City of Ottawa
Development Review Branch
Grading & Servicing Reviewed
Name: Eric Harrold
Signed: *Eric Harrold*
Date: Dec 09, 2020

Owner/Applicant
DCR/PHOENIX HOMES
Telephone # 723-9227
Plan # 4m-1593
Project name: DIAMONDVIEW ESTATES
Civic Address: 40 SOPWITH PVT
House model: MADISON C

LOT 46 SITE/GRADING PLAN
DIAMONDVIEW ESTATES

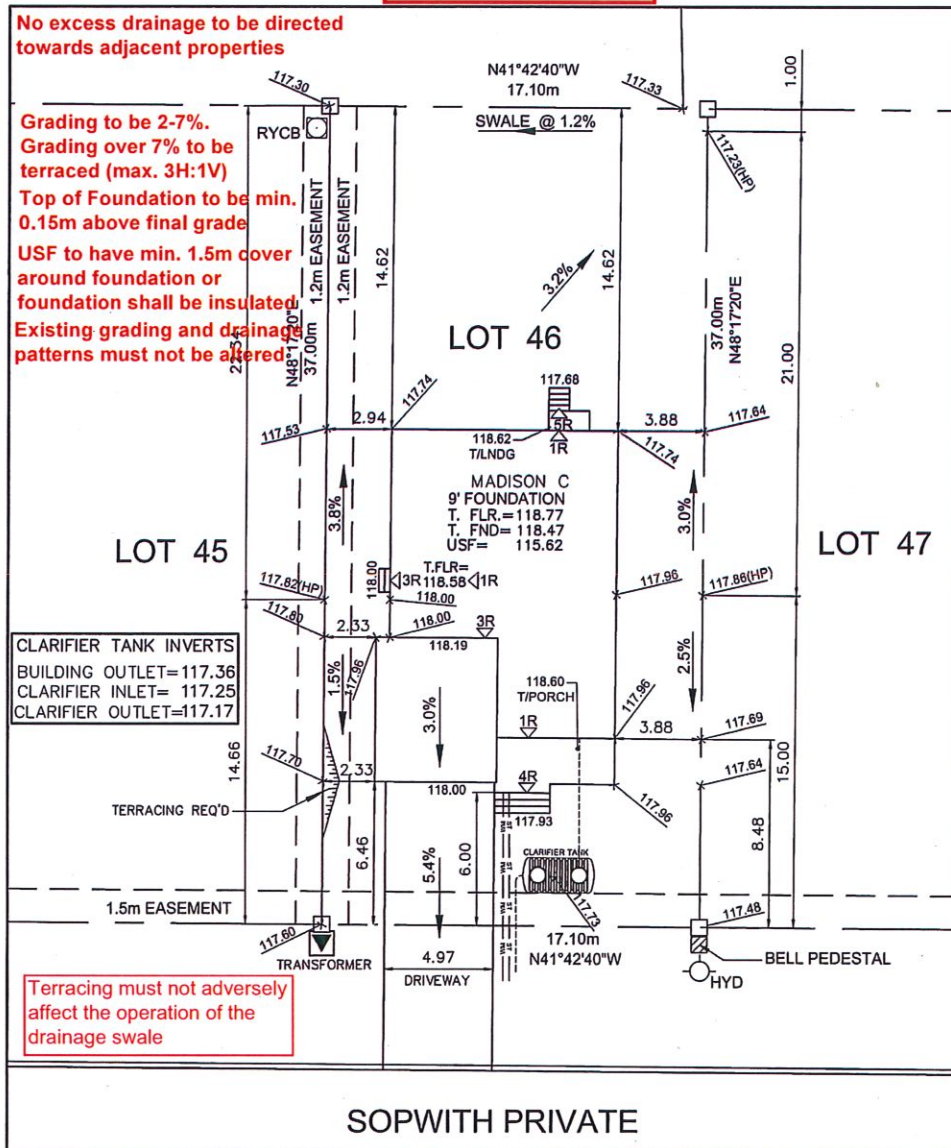
Encroachment on or alteration to any
easement is not permitted without
authorization from easement owner

No excess drainage to be directed
towards adjacent properties

Grading to be 2-7%.
Grading over 7% to be
terraced (max. 3H:1V)
Top of Foundation to be min.
0.15m above final grade
USF to have min. 1.5m cover
around foundation or
foundation shall be insulated.
Existing grading and drainage
patterns must not be altered

Terracing must not adversely
affect the operation of the
drainage swale

Maximum 2-22.5 degree horizontal radius
bends for each service. Bends must be
located on private property, spaced min.
1.0m apart, and 1.0m away from all valves

Sleeved services required under retaining walls /
footings / garage, and are recommended under
porches, decks, and similar structures
